# Modular Firmware

## V2.2.56\_220713 Release Note

Device Model	DS-KD8003-IME1、DS-KD8003-IME2
Firmware Version	V2.2.56_220713
iVMS-4200 Version	Latest version
Hik-Connect APP	Latest version

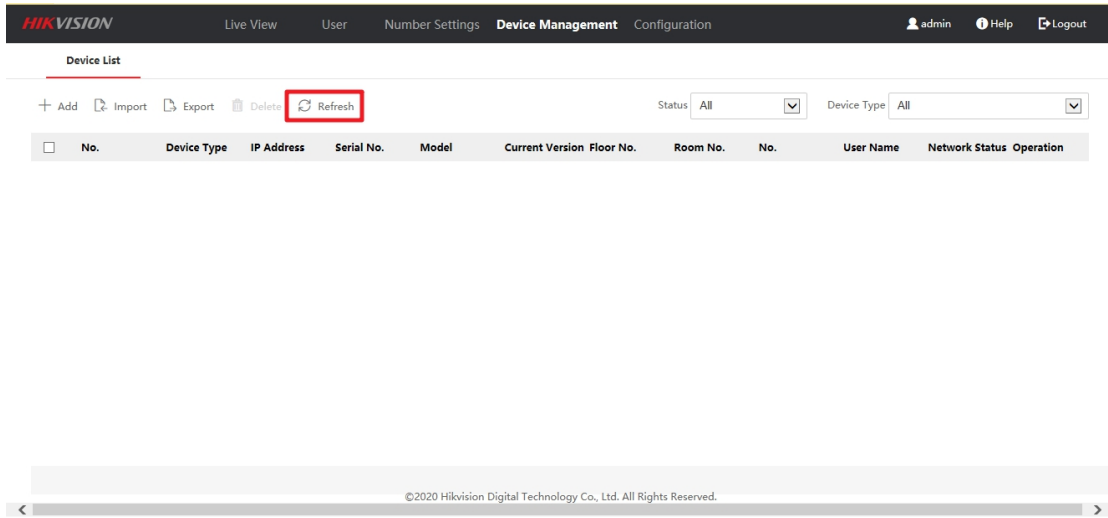
#### New Function

1. New refresh button is used to refresh the status of added devices

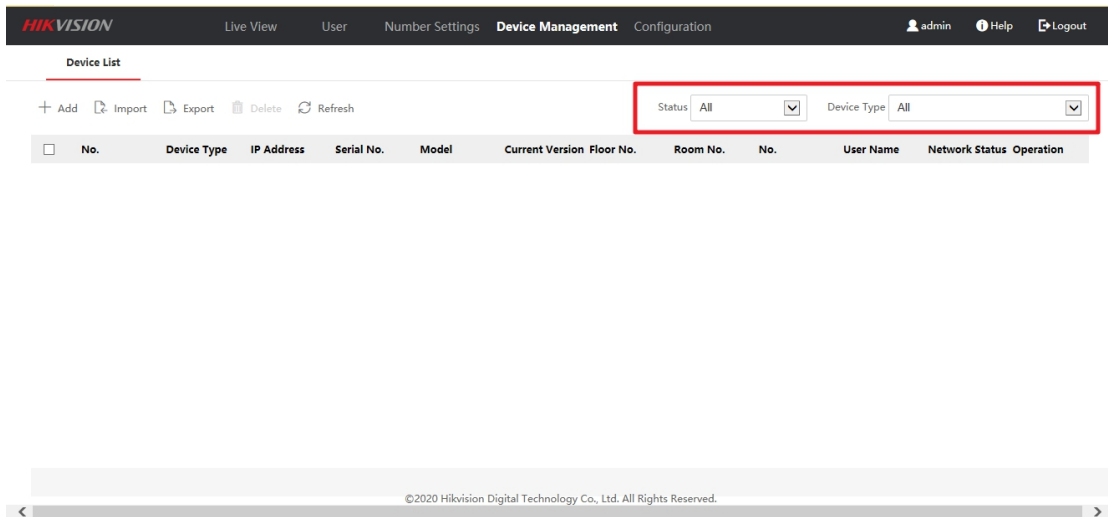
2. Added 'All' option, indoor station and sub-door station will be displayed together.
